Customer	: CU-DAR001 Dart Helicopters Services	Drawing Name	: HELI UTILITY BASKET LH/RH 350/355
Job Number	: 37511		
Estimate Number	: 10208		
P.O. Number	:	Part Number	: D350607043
This Issue	: 2/20/2008 S.O. No. :	Drawing Number	: D350-607 REV F P7-9
Prsht Rev.	: NC	Project Number	: N/A
First Issue	: 1/1 Type : LARGE FAB ASSY	Drawing Revision	: F
Previous Run	: 37247	Material	:
Written By	:	Due Date	: 3/7/2008 Qty: 1 Um: Each
Checked & Approved By	: <u>08 02 21</u>		
Comment	: Est Rev:E as Per DSI9318 06-01-24 JLM		
	: Est Rev:F ECN1068 07-12-21 DD verified by:

DESIGN <i>CP</i>	DRAWN BY <i>CP</i>	DART AEROSPACE LTD HAWKESBURY, ONTARIO, CANADA	
CHECKED <i>[Signature]</i>	APPROVED <i>[Signature]</i>	DRAWING NO. DSI 9318	REV. A SHEET 1 OF 1
DATE 06.01.06		TITLE WASHER ADDITION	SCALE NTS
A	06.01.06	NEW ISSUE

# DART SERVICE INSTRUCTION

TO AMEND INSTALLATION INSTRUCTIONS D350-607 REV. F

**-Figure 5- Basket Replacement Parts**  
(D350-607-043 Heli-Utility-Basket™)

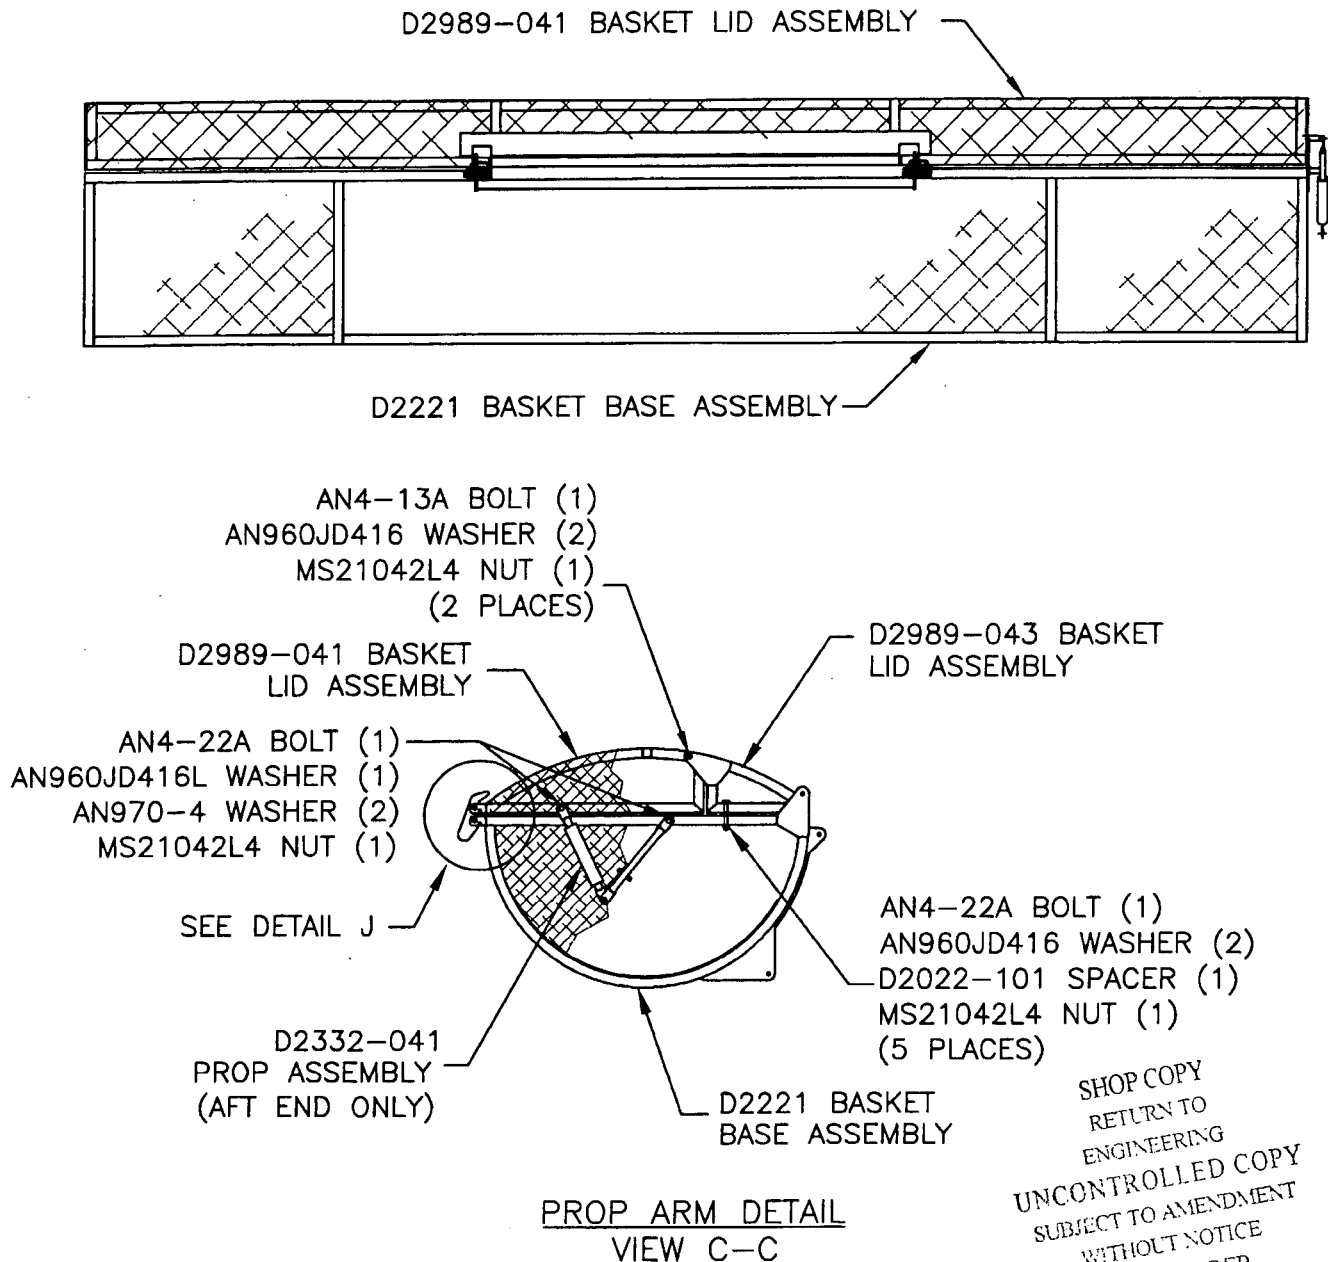
The corrected bolt stackup from Figure 5 of installation instructions D350-607 Rev. F is given below:

AN4-13A BOLT (1)  
AN960JD416 WASHER (1)  
HINGE PLATE (REF)  
**NAS1515H4 WASHER (1)**  
BASKET FRAME (REF)  
AN960JD416 WASHER (1)  
MS21042L4 NUT (1)  
(2 PLACES)

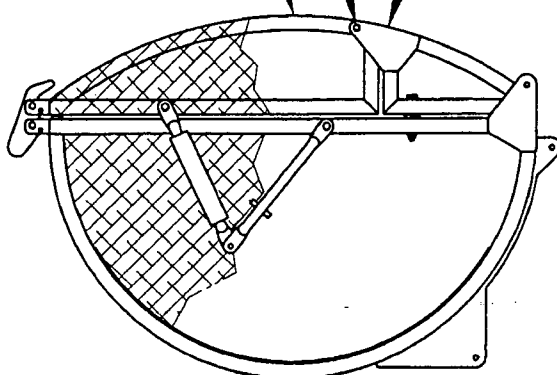
To reduce the possibility of damaging the finish, a **NAS1515H4** washer (2 places) has been added between the hinge plate and basket frame on the **D350-607-043/-047 Heli-Utility-Basket**.
